## Planning Committee

Wednesday, 3 July 2019, 6.00pm

| Contents   | Page |
|--|------|
| PC1907 -1 HIGH STREET, NO. 223 AND 225 (LOT 100 AND 475),<br>FREMANTLE - PARTIAL CHANGE OF USE (PUBLIC CAR<br>PARK) AND SIGNAGE - (TG DA0093/19)   | 3    |

**Image 3:** View from southern adjoining site (No.26 Pass Crescent)

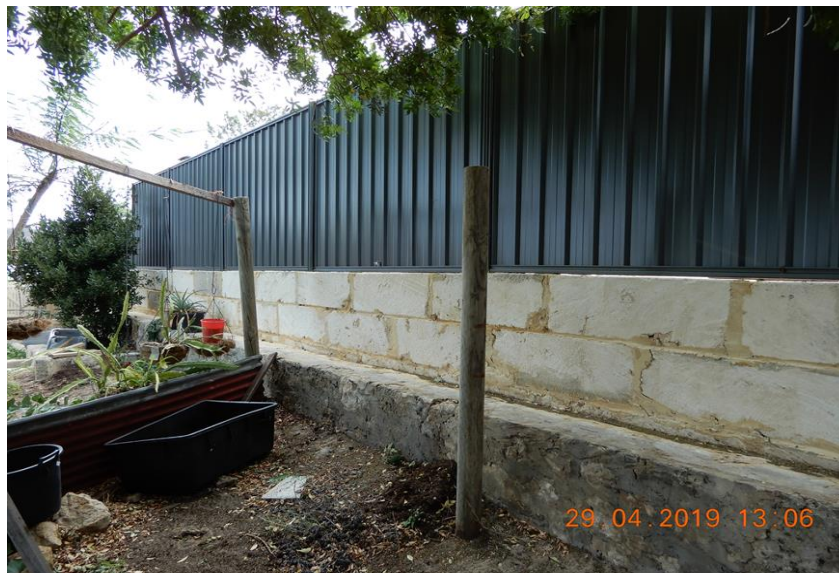
The City has received an objection during the consultation period raising a concern that the existing and new retaining wall, together with the 1.8m high fence, results in a high and overbearing wall along the common boundary. Furthermore concerns to the visual appearance of the unauthorised retaining wall have been also raised and that the wall appears to be unfinished with missing mortar. The portion of wall which exceeds the allowable 500mm provision can be seen below in the site photos from the neighbouring southern site (No. 26 Pass Crescent).

The area of the adjoining southern site directly abutting this portion of development mainly consists of raised garden bed (see aerial image below). This area is not considered to form part of the adjoining property’s exclusive outdoor living area (area readily accessible from the dwelling and capable of active and passive use) and given its location and positioning on this boundary, the building bulk and shadow impacts created are not considered to be significantly detrimental to the amenity of the neighbouring property. As such, the portion of over height dividing fence is considered supportable.

**Image 5:** Extract from plans illustrating areas of fill

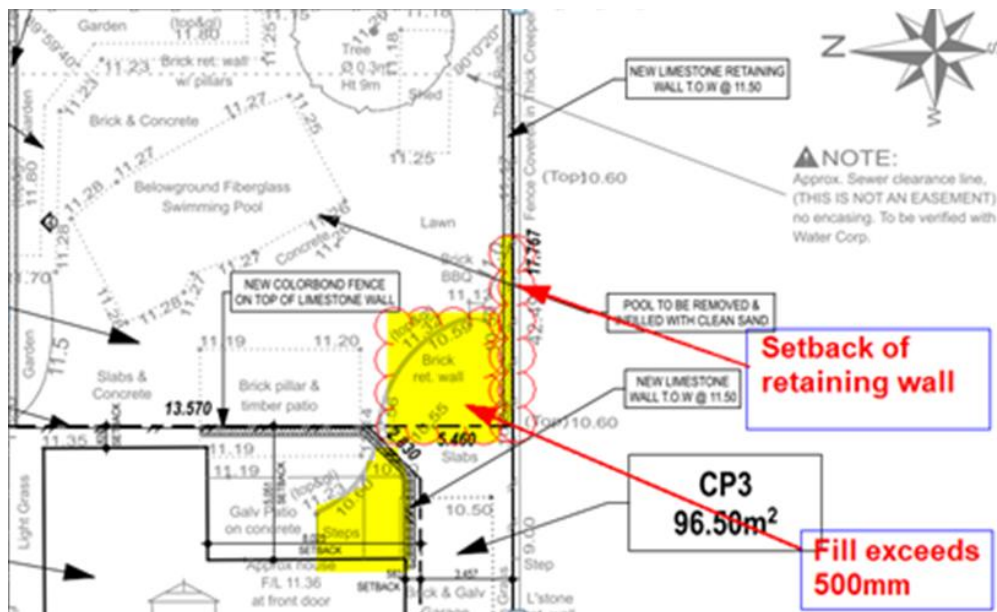
For simplicity reasons below is an extract of the development plans indicating the portion of site which is impacted by the proposed fill exceeding 500mm above natural ground level of the subject site and the portion of the southern common boundary with a reduced setback for the retaining wall.

The proposal is considered to meet the Design principles of the R-Codes relating to site works and setback of retaining walls in the following ways:

**Figure 1:** Overshadowing elevation

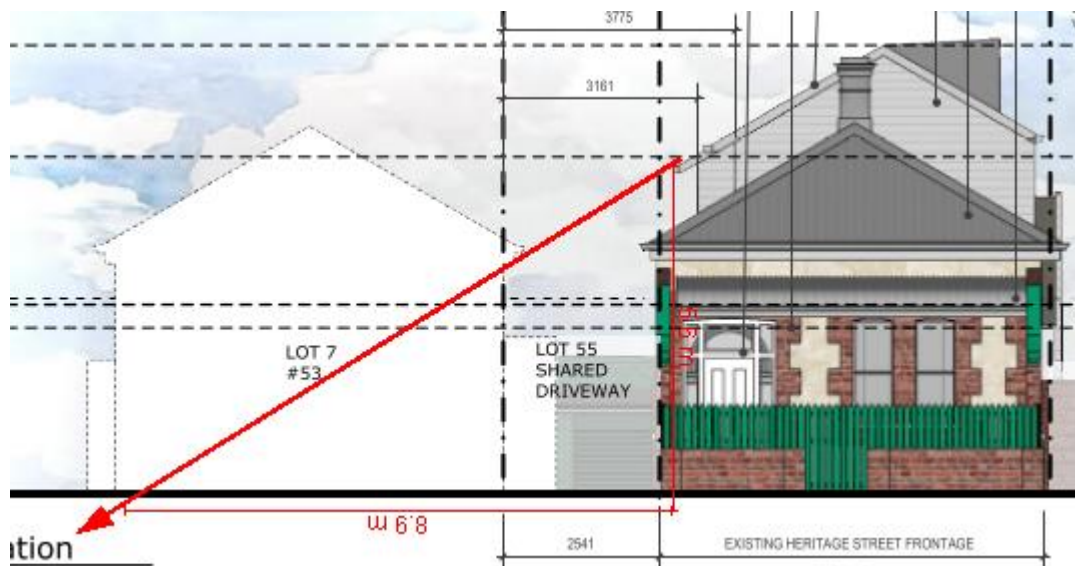
The solar access variation is considered to meet the Design principles of the R-Codes in the following ways:

- The existing development presents 38.4 % (111.7m<sup>2</sup>) overshadowing, resulting in 16.9% (49.3m<sup>2</sup>) additional overshadowing.
- The overshadowing does not fall onto the solar panels of the adjoining lot as shown in Figure 1 below.

**Figure 2: Overshadowing diagram (Plan A-02)**

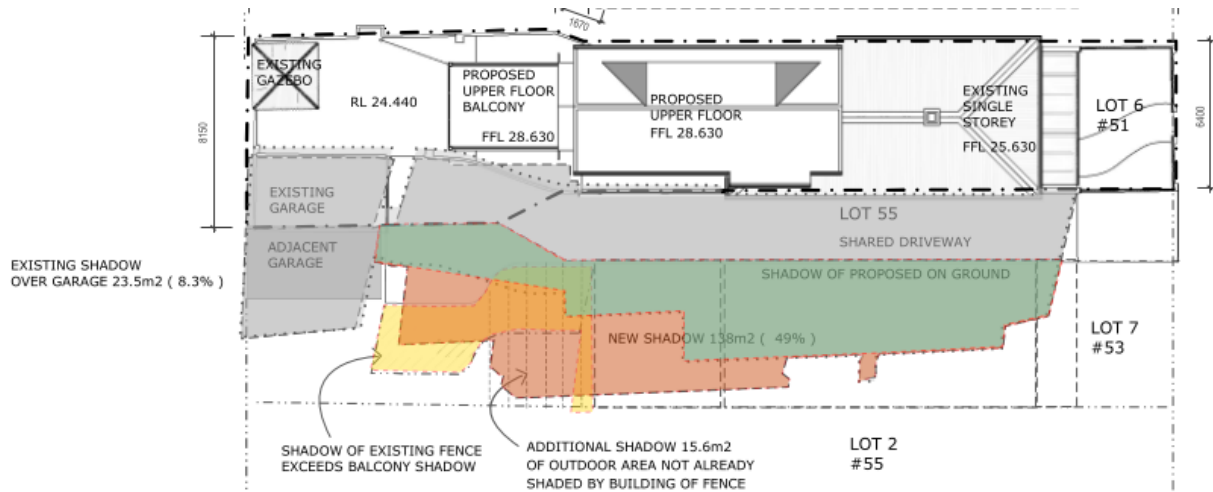
- The adjoining southern lot contains a garage and a dividing fence whose shadows will exceed the length of the shadows of the proposed extension. The new extension presents only 15.6m<sup>2</sup> additional shadow beyond the shadows already created from the existing structures (see figure 2 below).
- The additional overshadowing avoids the majority of the outdoor living area, and the adjoining neighbour has signed the overshadowing diagram indicating no objection.
